ELECTRICAL—BRAKE LAMPS STAY ON—VEHICLES BUILT THROUGH 9/22/2000	Article No. 01-16-2

MERCURY: 1999-2001 COUGAR

Figure 1 - Article 01-16-2

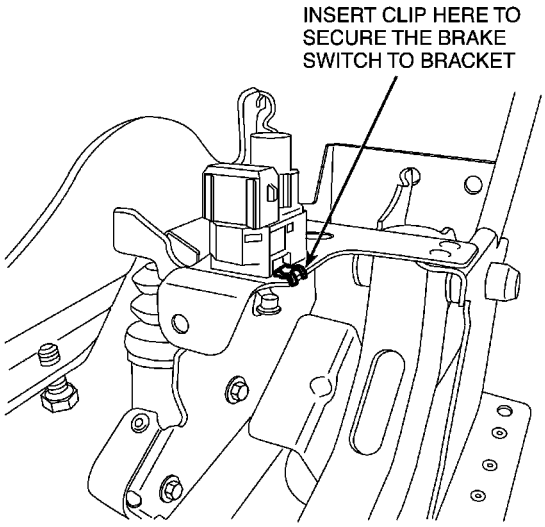
Some vehicles built prior to 09/22/2000 may exhibit the brake lamps staying on. This may be caused by the brake lamp switch being moved out of position.

Remove the Brake Lamp Switch and reinstall to ensure proper positioning. Install "Clip" 1S8Z-2C540-AA, to secure the Brake Lamp Switch to the pedal bracket. Refer to Figure 1 for location description.

Install clip 1S8Z-2C540-AA, to secure the Brake Lamp Switch to the pedal bracket. Refer to the following Service Procedure for details.
